AC Boardwalk Restroom
Renovation
Atlantic City, NJ

NO.	DATE:	DESCRIPTION:
1	2020 07 13	ADDENDUM 04
	2020 07 07	ISSUED FOR DCA REVIEW

DRAWING TITLE:
MISSISSIPPI AVENUE
ELECTRICAL NEW
FLOOR PLANS
POWER & LIGHTING

DRAWN BY: CEG
REVIEWED BY: CEG
PROJECT NO. 19074.00
DRAWING NO. 03 E-101

2 NEW WORK FLOOR PLAN – LIGHTING
03 E-101 SCALE: 1/4"=1'-0"

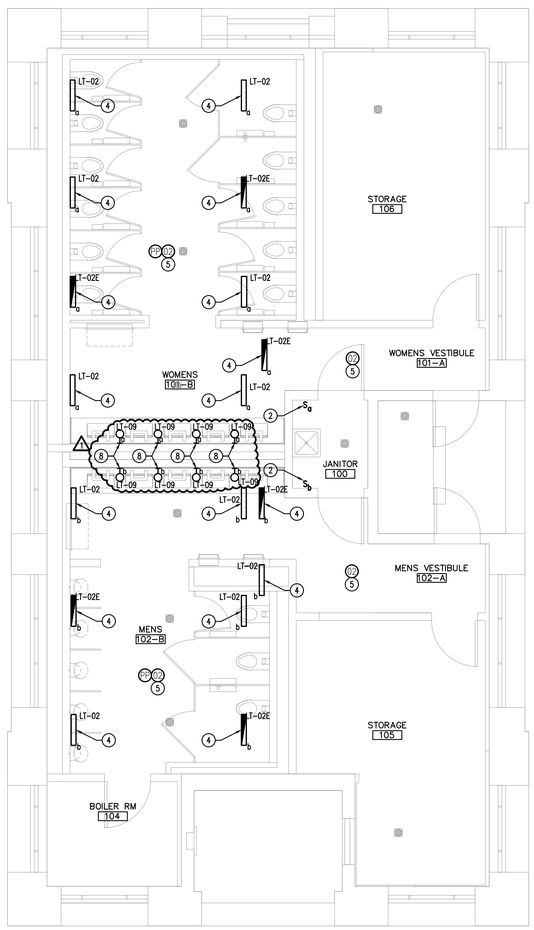
1 (8) PROVIDE NEW DEDICATED 20A/1P CIRCUIT BREAKER IN EXISTING 208Y/120V ELECTRICAL PANEL FOR NEW LIGHTING POWER REQUIREMENTS. UTILIZE 2#12 & 1#12 G – 3/4" C. PROVIDE SEPARATE POWER PACK AS REQUIRED FOR CONTROL OF 120V LIGHTS.
